# Mlouhi Center

City of El Paso — City Plan Commission — 12/6/2018

SUSU18-00091 — Major Combination

### **Airport Road:**

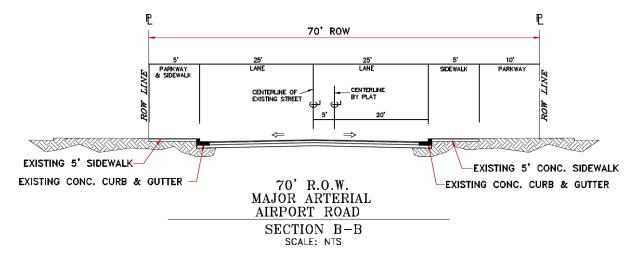
- 40' of roadway participation is required for Airport Road. Only 20' currently exists. An additional 20' of roadway is required. The applicant is requesting to not be required to pave their proportionate share of the roadway.
- The parkway is currently 15', consisting of a 5' sidewalk abutting the street and a 10' parkway abutting the subject property. The applicant is requesting not to be required to install the bike and hike.
- The applicant is required to dedicate an additional 20' of right-of-way. With the request to not be required to pave their proportionate share of the roadway, the dedication would be located within the parkway, bringing the total width to 35'. There is enough right-of-way to install the bike and hike.

### **Montana Avenue:**

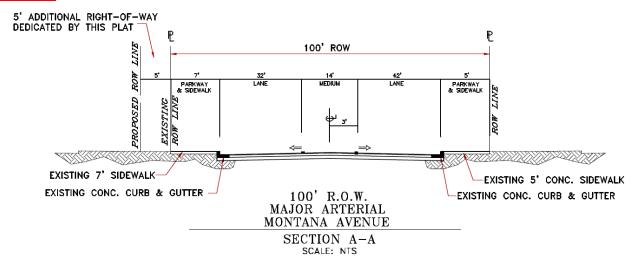
- 40' of roadway participation is required for Montana Avenue. 43' currently exists. This is 3' over the minimum requirement.
- The parkway is currently 7' and consists of a 7' sidewalk which abuts the street. The applicant is requesting to not be required to install the bike and hike.
- The applicant is required to dedicate an additional 5' of right-of-way. Since Montana Avenue is a TXDOT right-of-way, the dedication would be located within the parkway, bringing to total width to 12'.
